NUMBER: 19-003-07 REV. A

THIS BULLETIN SUPERSEDES TECHNICAL SERVICE BULLETIN 19-003-07, DATED MAY 19, 2007, WHICH SHOULD BE REMOVED FROM YOUR FILES. ALL REVISIONS ARE HIGHLIGHTED WITH **ASTERISKS**** AND INCLUDE A REVISION TO THE PART NUMBER.**

Leak At Steering Damper Due To Orientation Of Damper Rod To Vehicle

2007 (JK) Wrangler

Fig. 1 STEERING DAMPER - TYPICAL

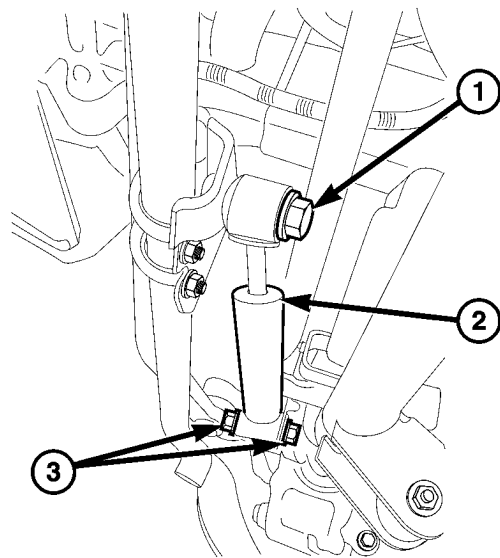
The customer may notice that there is a slow fluid leak at the steering damper seal. This condition may be due to the orientation (mounting) of the steering damper to the vehicle. If the rod end of the steering damper is attached to the axle bracket, then the rod may be more susceptible to rock/stone contact. Rock/stone contact may damage the surface of the damper rod, which in turn, can damage the damper seal.

Mounting (orienting) the steering damper so that the damper rod is attached to the tie rod (versus the axle bracket), will better protect the damper rod from possible rock/stone damage.

NOTE: It is important that the steering damper be correctly oriented to the vehicle. The rod end of the steering damper is to connect to the tie rod.

4. Install the **ROD END** of the new steering damper **TO THE TIE ROD**. Hand install attaching nut (Fig. 1).
5. Install the **BODY END** of the new steering damper **TO THE AXLE BRACKET**. Hand install attaching nut/bolt.
6. Tighten each attaching fastener to 68 Nm (50 ft. lbs.).
7. Lower vehicle.

- 1 - Attach Rod End Of Steering Damper To Tie Rod
- 2 - Steering Damper
- 3 - Attach Body End of Steering Damper To Axle Bracket
